REVISIONS	
3 Redline No.3 Revised based on HDD comments	10-23-98
4 Redline No.4 Revised based on HDD comments	04-09-99
DMP DC	
3 ADDENDUM 3 MARCH 5, 1998	
© ADD PEDS AND REPLACE CABLE WITH STREETSCAPE PROJECT	11/97
DMP DC

MARYLAND DOT - STATE HIGHWAY ADMINISTRATION

MD 924 (BOND STREET) @ MD 22 (CHURCHVILLE ROAD)

DRAWN BY: G. SIMMERS	F.A.P. NO.	STPG-000S(494)E	PLAN SHEET NO.:	SHEET NO.
CHECK BY:	S.H.A. NO.	AW-104-501-585	1479 C	41 OF 66
SCALE: 1"=20'	COUNTY	HARFORD

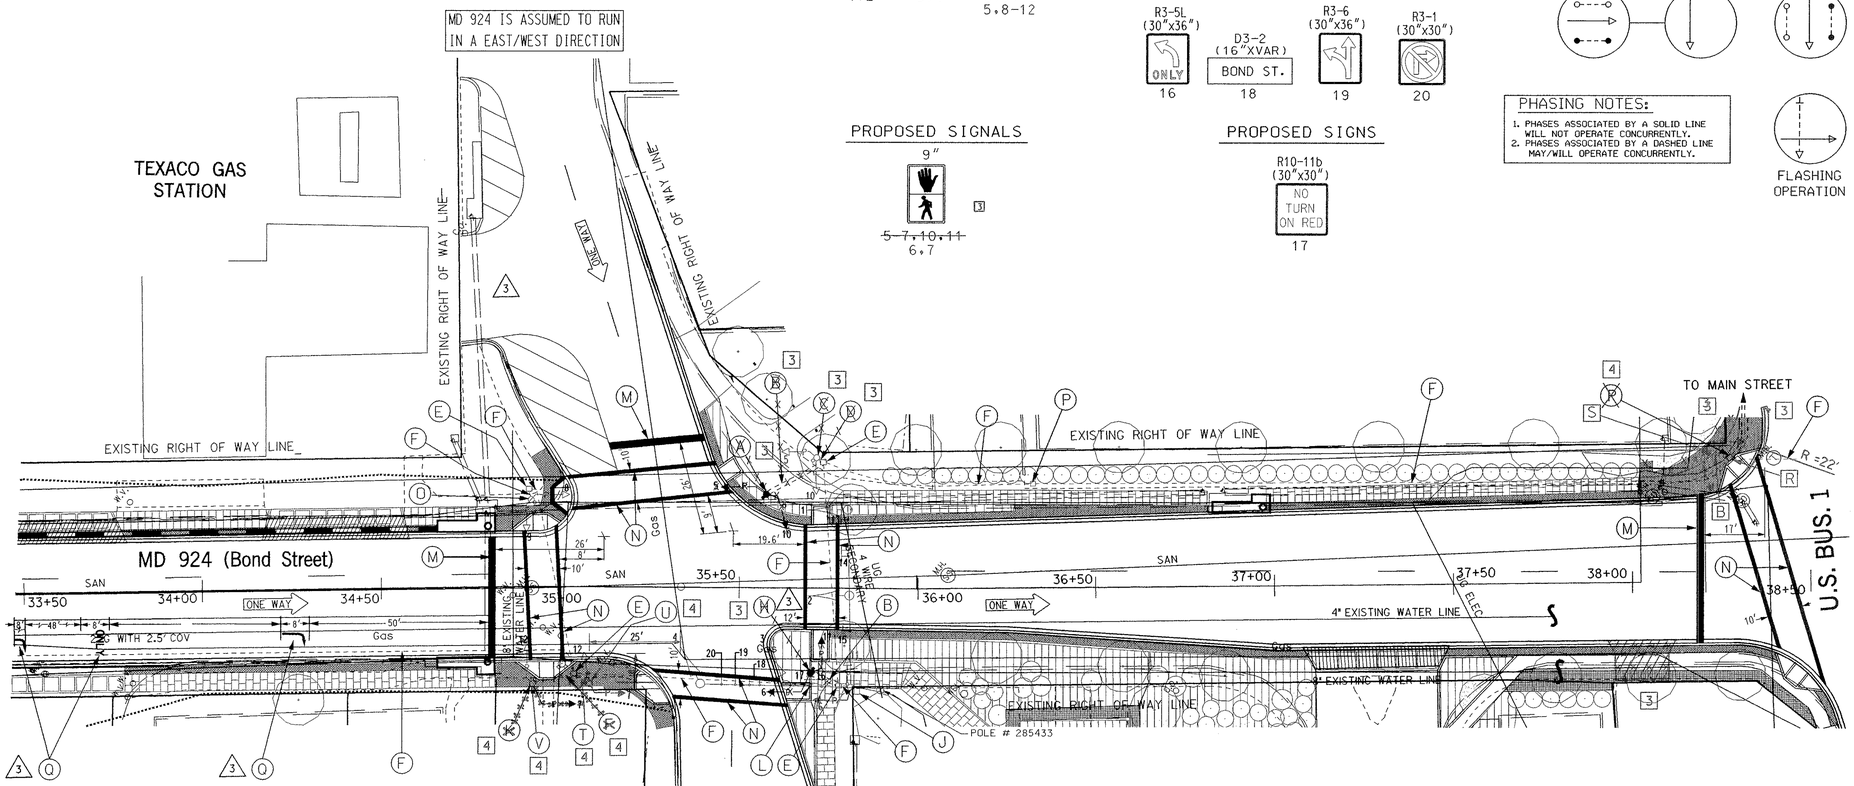
4 T. Install 2 in. PVC schedule 80 electrical conduit - trenched. (Note: installation requires the removal and replacement of existing sidewalk).

4 U. Relocate pedestal pole with breakaway base, pedestrian signal head and push button to sta. 35+08: right 27 ft. Install proposed pedestrian signal head, as shown. (Note: Contractor to install ground rod in pole foundation , a new 2 in. PVC schedule 80 conduit bend and four - 1 in. x 40 in. anchor bolts. Also, contractor shall pull back existing cables and reroute to relocated pedestal pole.)

4 V. Existing pole to be relocated to sta. 35+08: right 27 ft.

12" R Y G 1.2 — 8" R Y G 3.4 — 9" 3 ~~8,9,12~~ 5,8-12

9" 3 ~~5,7,10,11~~ 6,7

R10-11b (30"x30") NO TURN ON RED 17

3 A. ~~Install 10 ft. pedestal pole with breakaway base, signal heads and pedestrian push button at sta. 35+57: left 26 ft. (Note: One - 2 in. PVC schedule 80 conduit bend and four - 1 in. x 40 in. anchor bolts. Also, install ground rod in pole foundation.)~~

3 G. DELETED

3 H. ~~Install 10 ft. pedestal pole with breakaway base, signal heads, and~~ push button at sta. 35+70: right 24 ft. (Note: one - 2 in. PVC schedule 80 conduit bend and four - 1 in. x 40 in. anchor bolts. Also, install ground rod in pole foundation). Also, install pedestrian signal head as shown.

3 M. Install 24 in. white thermoplastic pavement marking tape.

3 N. Install 12 in. white thermoplastic pavement marking tape.

4 ~~P. Use/adjust existing handhole to final grade.~~

3 Q. INSTALL PERMANENT PREFORMED PAVEMENT MARKING LETTER AND/OR ARROW AS SHOWN.

3 R. Adjust exiting handhole to final grade and install ground rod.

3 S. Install 10 ft. pedestal pole with breakaway base, signal heads and pedestrian push button at sta. 38+20.5: left 37 ft. (Note: One - 2 in. PVC schedule 80 conduit bend and four - 1 in. x 40 in. anchor bolts).
